PSE&G Public Service
Electric and Gas
Company

SAFETY EVALUATION REPORT
OPEN AND CONFIRMATORY ITEM STATUS
HOPE CREEK GENERATING STATION
DOCKET NO. 50-354

SER Confirmatory Item No. 14 (SER Section 6.3.5 and 15.9.3)

Loss-of-Coolant-Accident Analysis

Title: Fuel Rod Convective Heat Transfer Coefficient
vs. Time After Break (Small Break Model)
(Main Steam Line Break Outside Containment,
Failure of Channel A DC Source)

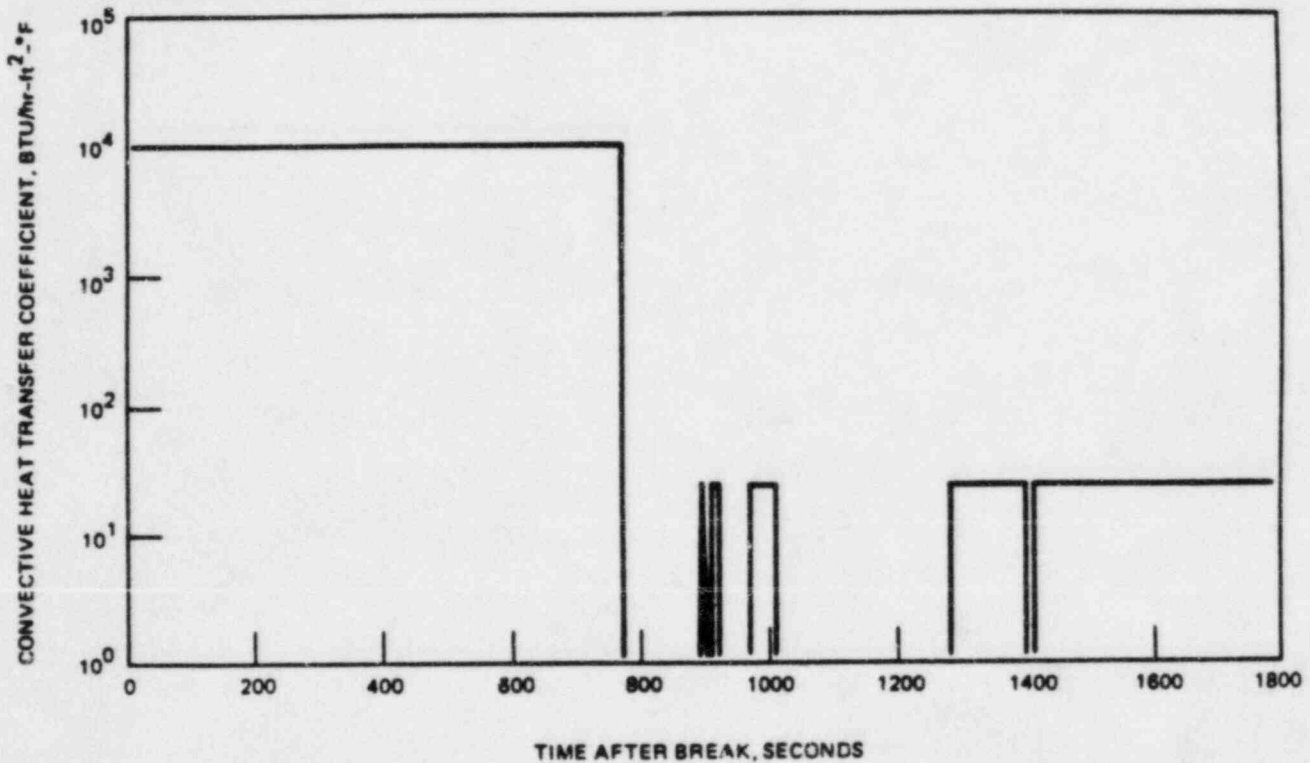
6.3-60
This replaces Figure 6.3-60.

Title: Peak Cladding Temperature vs Time After Break
(Small Break Model) (Maximum Main Steam
Line Break Outside Containment, Failure of
Channel A DC Source)

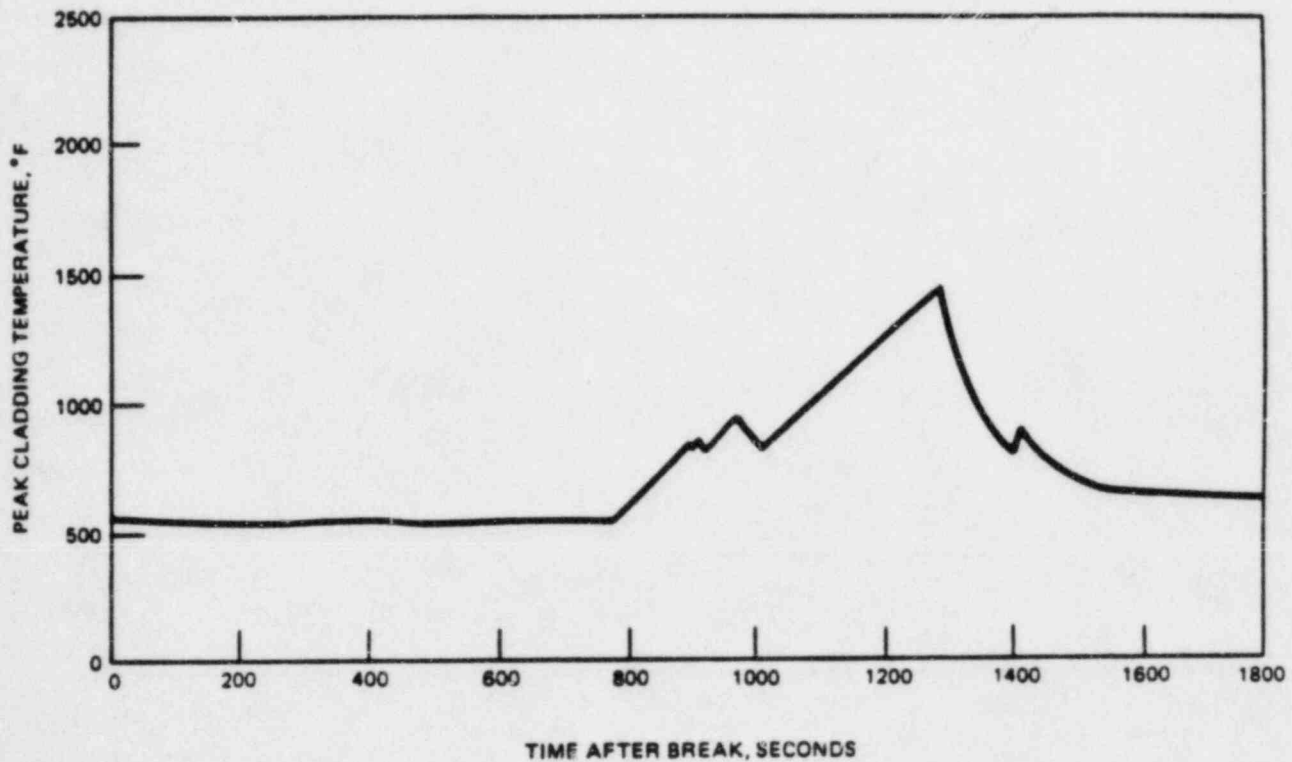
This is new Figure 6.3-61.

Title: Total Time Highest Powered Node Remains Uncovered vs Break Area (Failure of Channel A DC Source)

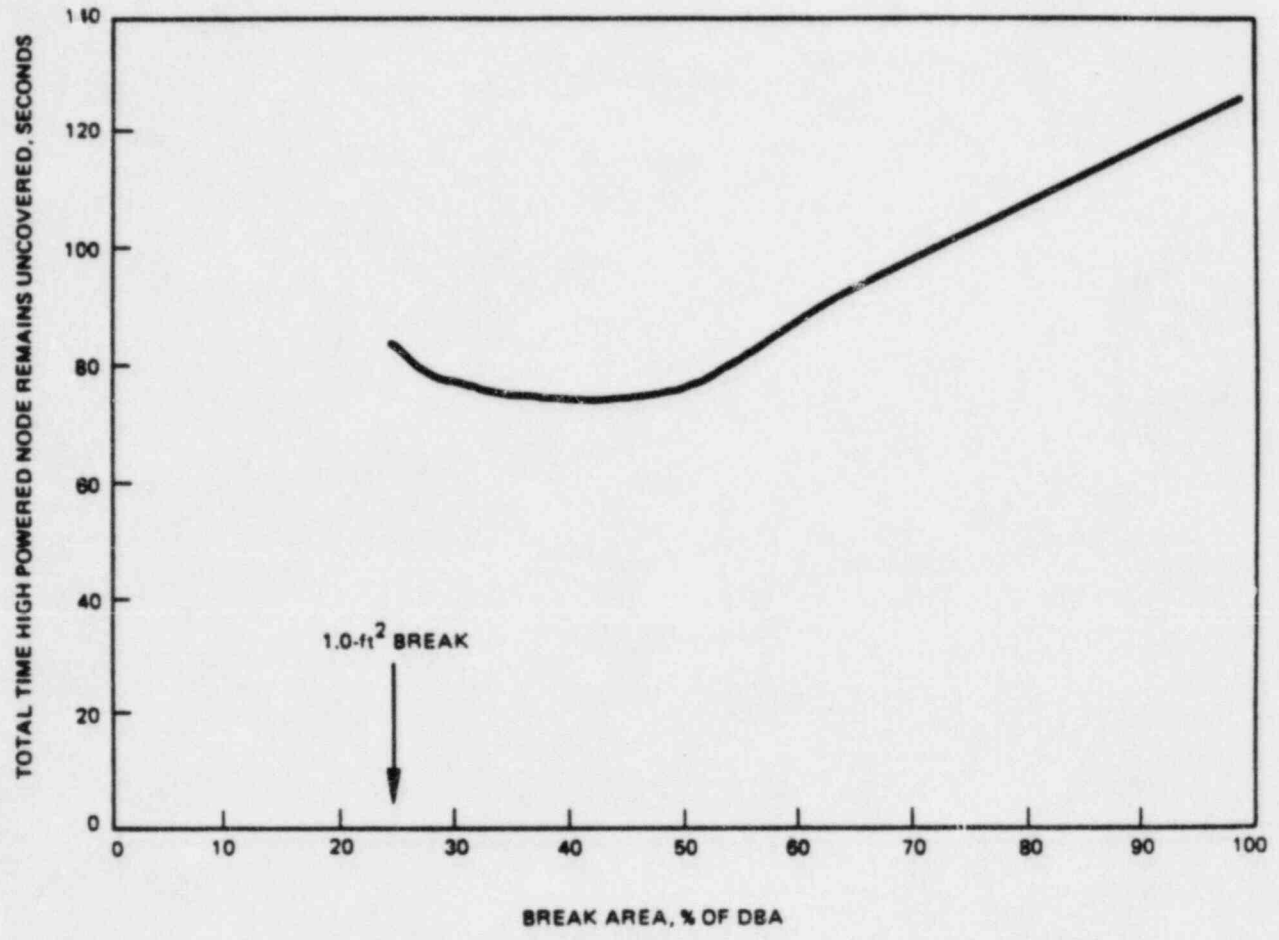
Figure 6.3-⁶²~~60~~ shows the variation with break size of the calculated time the hot node remains uncovered. Based on these calculations, the design basis accident (DBA) was determined to be the break that results in the highest calculated peak cladding temperature in the 1.0 ft² to 4.1 ft² region (the largest possible area of a recirculation system line break is 4.1 ft²). Confirmation that this is the most limiting break over the entire break spectrum is shown in Figure 6.3-14.

This is new Figure 6.3-62
